INDIANA DEPARTMENT OF TRANSPORTATION

APPROVED MINUTES

November 17, 2023, Standards Committee Meeting

RE: Minutes from the November 17, 2023, Standards Committee Meeting

724-B-147d ALTERNATE SS JOINT (proposed to delete)

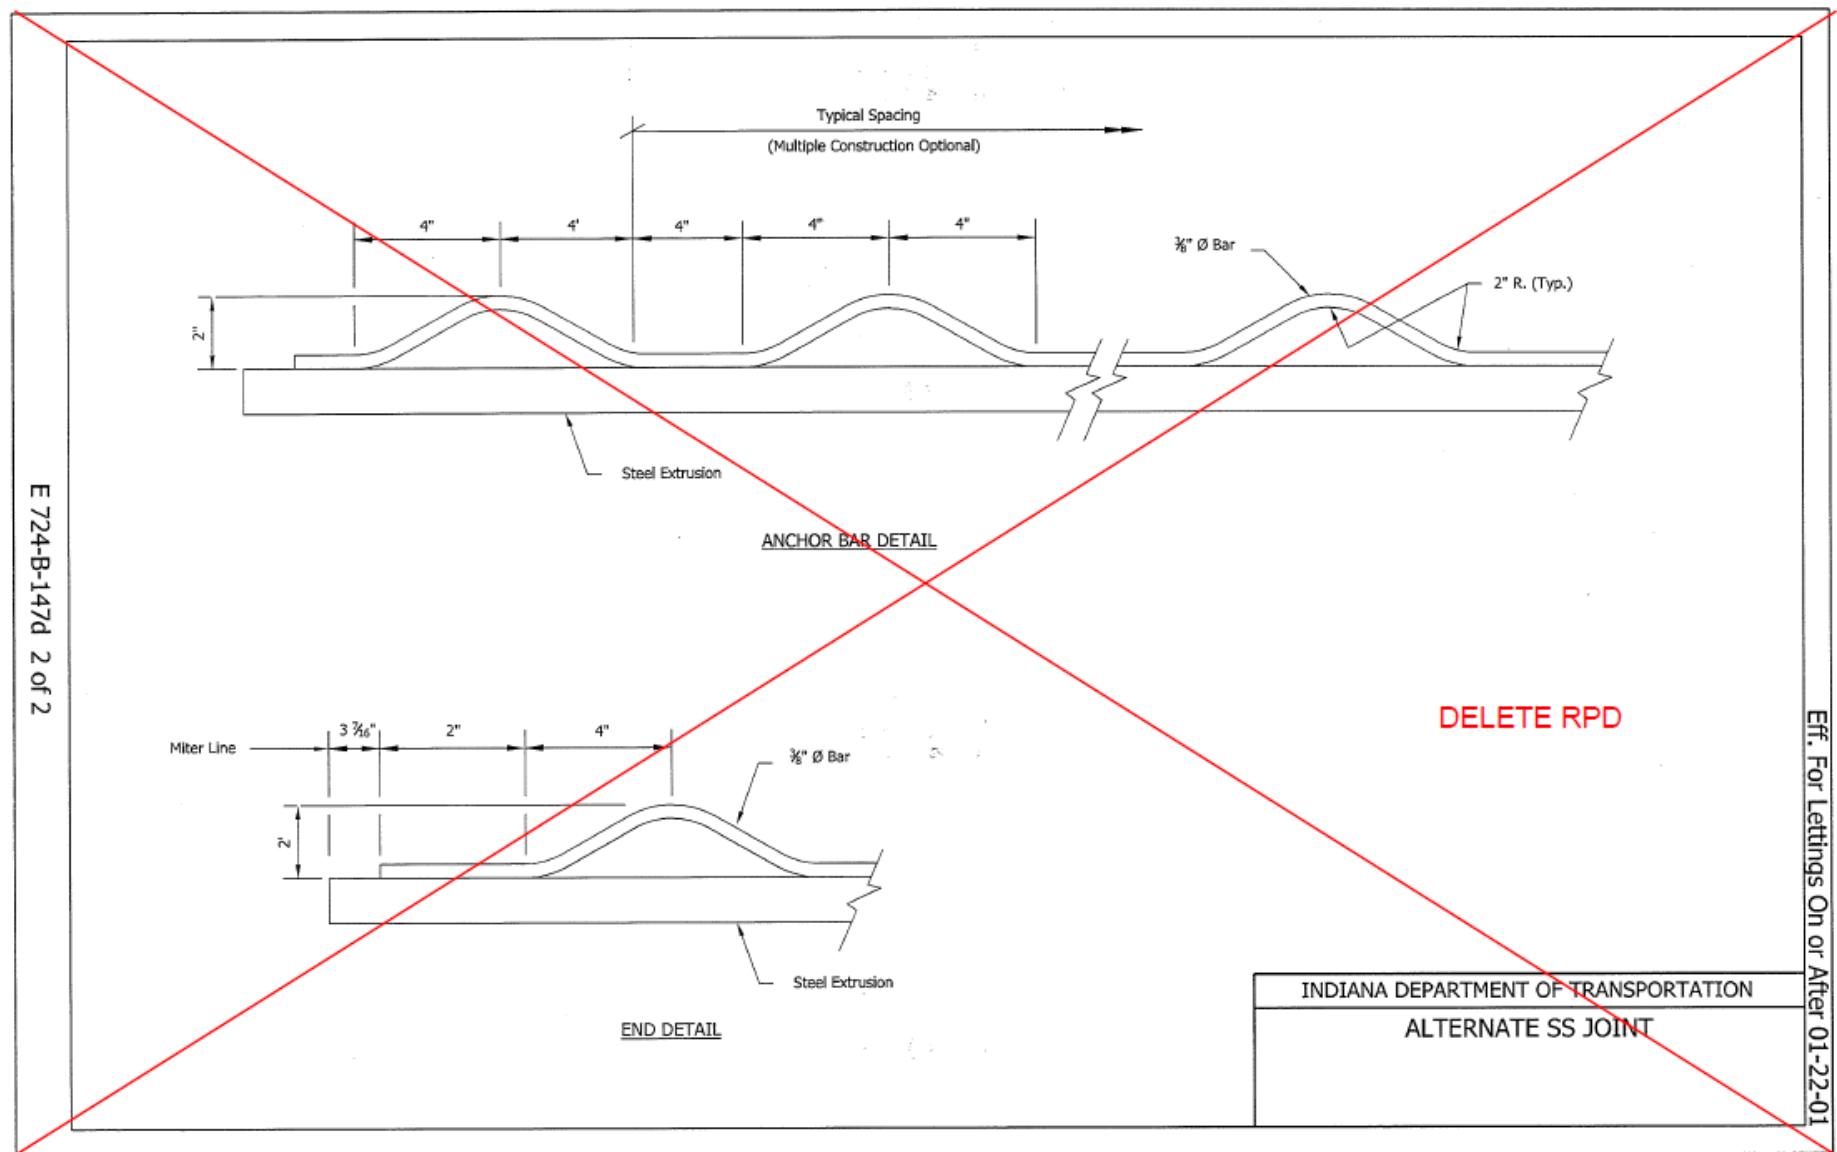
PROBLEM(S) ENCOUNTERED: The Alternate SS Joint, as shown on recurring plan detail RPD 724-B-147d, has experienced early failures at several locations.

PROPOSED SOLUTION: Eliminate RPD 724-B-147d

Provide any further information as to why this proposal should be placed on the Standards Committee meeting Agenda: This joint type has proven to have a short service life and shouldn't be used on future projects.

Mr. White introduced and presented this item explaining that the Alternate SS Joint, as shown on recurring plan detail RPD 724-B-147d, has experienced early failures at several locations.

Mr. White therefore proposed to eliminate RPD 724-B-147d.

E 609-RCBA-04 REINFORCED CONCRETE BRIDGE APPROACH SECTION, PAVEMENT LEDGE, AND BAR BENDING DETAILS (shown markups)

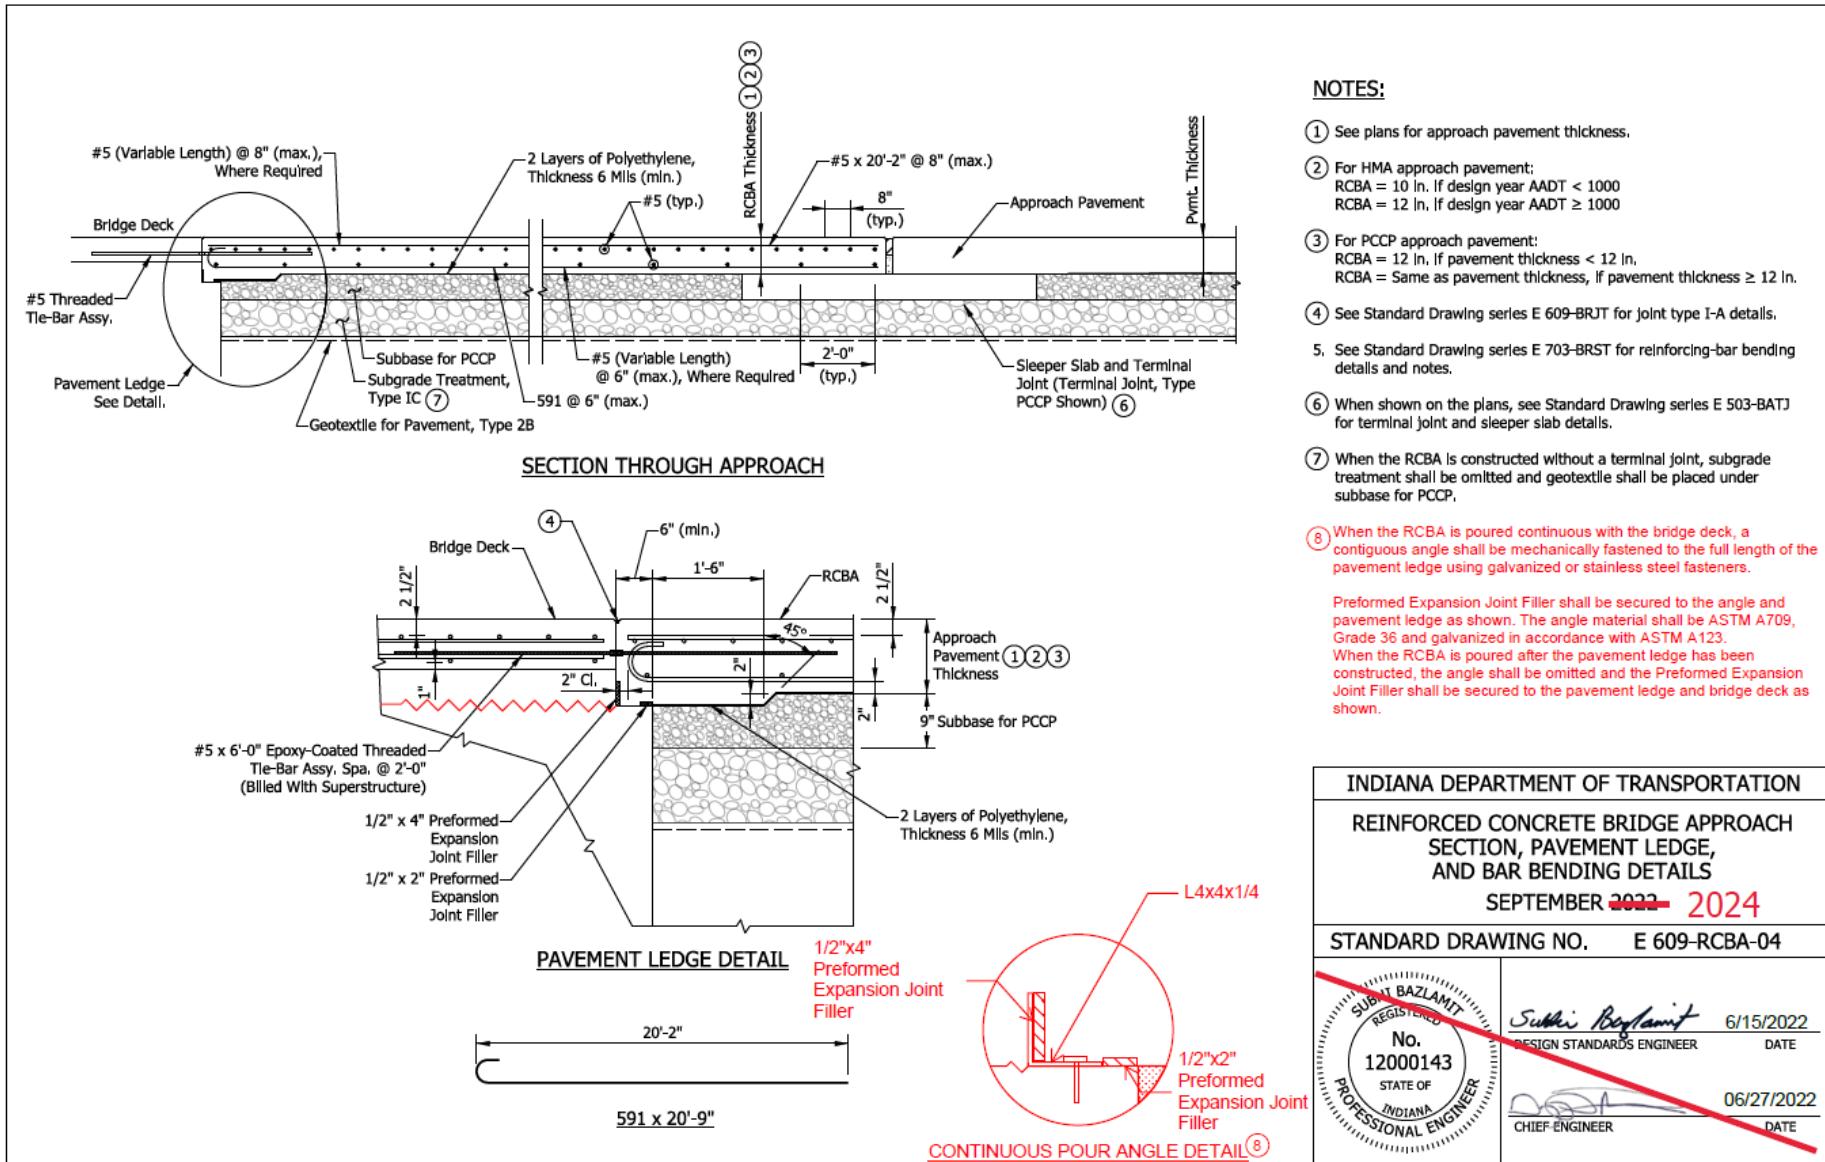
Prior to [Construction Memo 07-23](#), concrete bridge decks and approaches could be poured continuously. Since after the memo, bridge decks and approaches were required to be poured separately due to the random cracking occurring around the 1-A joint, both during and after the pour. This caused the need for repairs that are both costly for the Contractor and detrimental to the expected life of the concrete.

As construction techniques and methods improved over the years, Industry Leadership expressed interest again in pouring the bridge deck and approaches monolithically together. As a result, the Department facilitated a pilot program for the past two years to review the impacts of the continuous deck pours. The pilot projects concluded that this method promotes a smoother ride between the deck and approach transition and eliminates two cold joints. Further, this method is quicker and more cost effective.

A specification change would allow the Designer of Record to review the Contractor's bridge deck pour sequence and determine if the structure can be poured monolithically. Determining factors include pouring the first span in less than 3.5 hours and the skew of the structure to be less than or equal to 45 degrees. A Design Memo is planned to be published to convey changes to the IDM and Bridge Design Aid 404-01. Furthermore, the revised Standard Drawings, E 609-RCBA-04, includes the requirements for an embedded steel angle component, that will keep the preformed expansion joint filler in place at the 1-A joint location across the structure. Further, a Construction Memo is planned to be published to supersede CM 07-23.

Bridge approaches shall not be poured continuous with deck pours. *An exception will be considered when the bridge skew is less than or equal to 45 degrees and approved as part of the Contractor's concrete deck pour sequence. If the Contractor elects to pour the bridge approaches and deck continuously, the Contractor shall include the method of identifying type I-A joint locations as a part of the concrete deck pour sequence submittal.*

E 609-RCBA-04 REINFORCED CONCRETE BRIDGE APPROACH SECTION, PAVEMENT LEDGE, AND BAR BENDING DETAILS (draft)

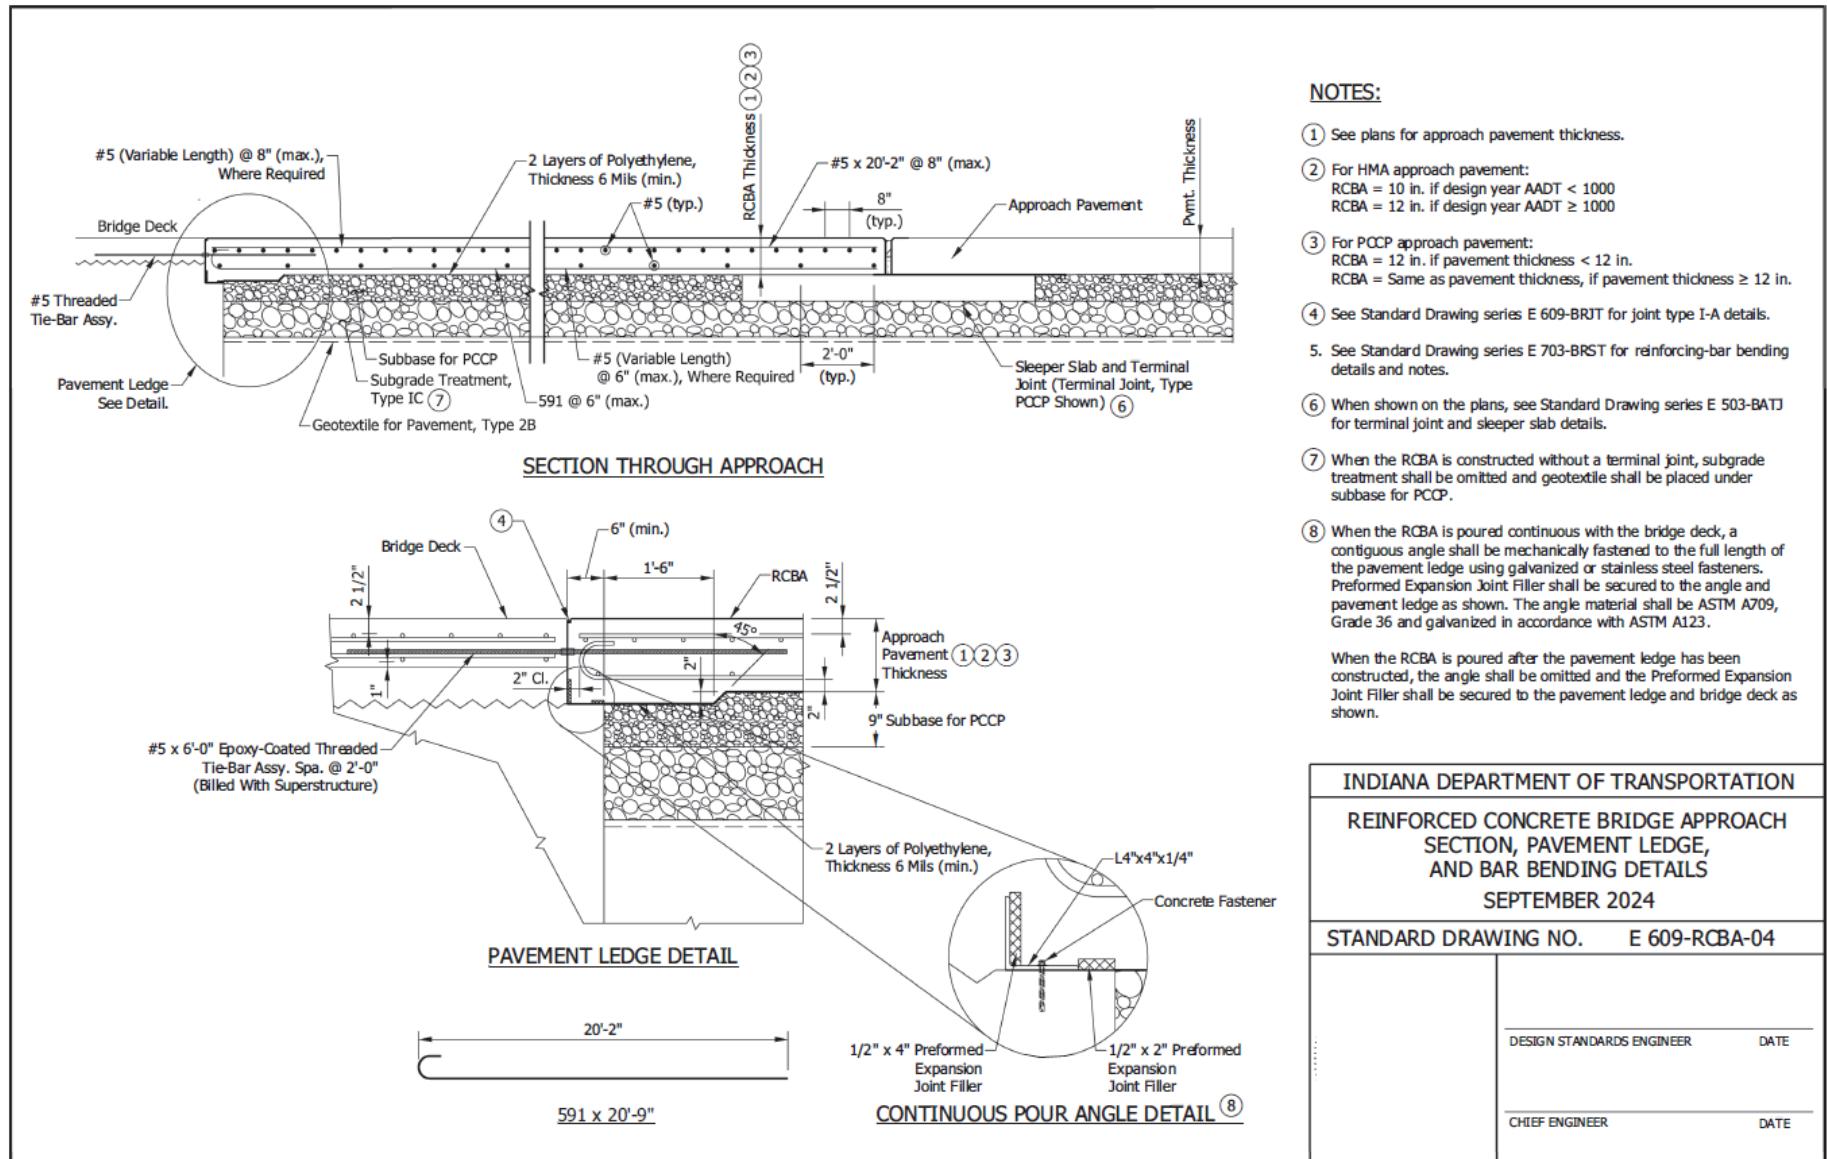
This item was introduced and presented by Mr. Novak who stated that prior to Construction Memo 07-23, concrete bridge decks and approaches could be poured continuously, as explained on the proposal sheet.
